Product Change Notification
Software Release Notice

MultiConnect[®] rCell 100 Series Cellular Routers

mPower[™] Edge Intelligence mPower 5.2 Firmware Available

Product Change Notification Number
PCN 05282020-MTR-001

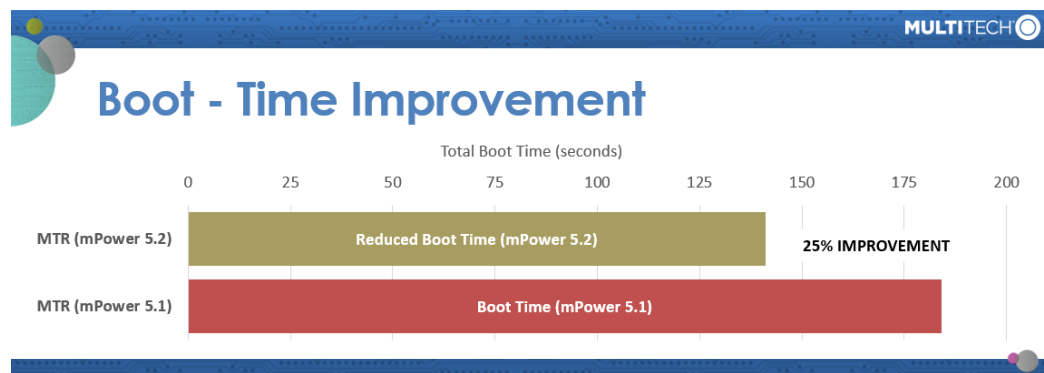
1. Reduced Boot Time Previous versions of mPower resulted in longer boot times. mPower 5.2 includes new features and optimization that decrease the device boot time up to 25% [GP-256, GP-360, GP-362, GP-363, GP-364]

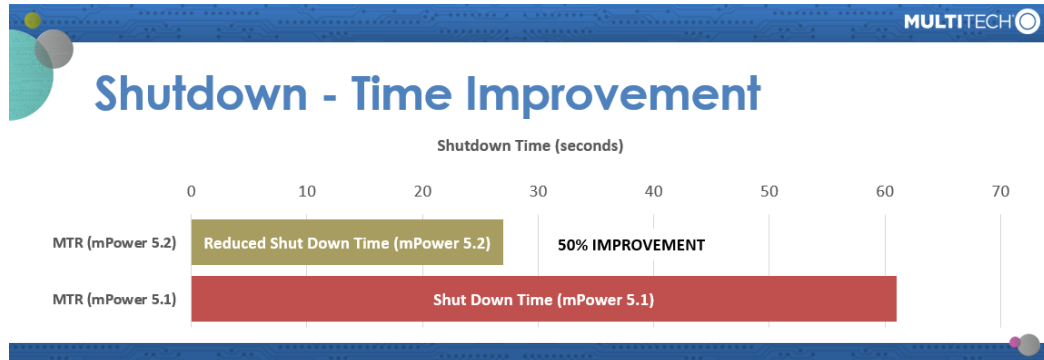
2. Shutdown Time Optimization: When restarting a device, the total time to reboot also includes shutdown time. Previous versions of mPower resulted in longer shutdown times. mPower 5.2 has been updated to reduce shutdown time. MTR mPower shutdown time has been shortened by 50%.

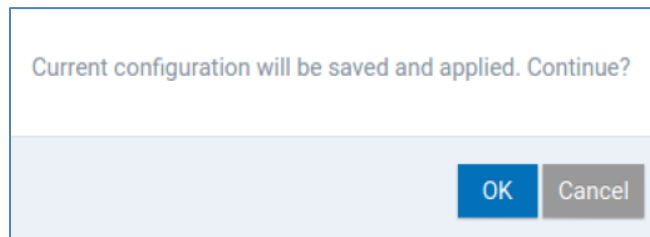
3. Save and Apply Configuration Settings without Restarting: Previous versions of mPower required a device reboot for most system configuration settings. mPower 5.2 has been updated to save and apply many configuration settings without the need to restart. In these cases, the user will be presented a “Save and Apply” button after making configuration settings. If “Cancel” is selected, changes are not saved. [GP-339]

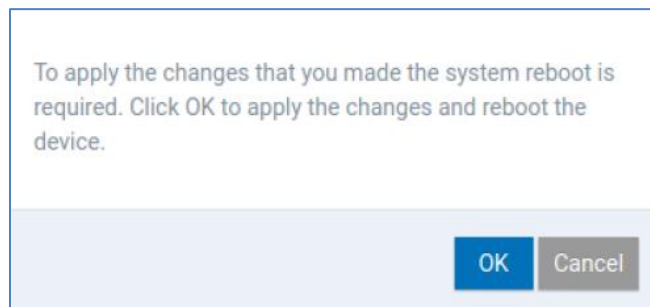
A limited number of system configuration setting changes will still require the device to be restarted. In these cases, the user will be presented with a “Save and Reboot” button after making configuration settings. If “Cancel” is selected, changes are not saved.
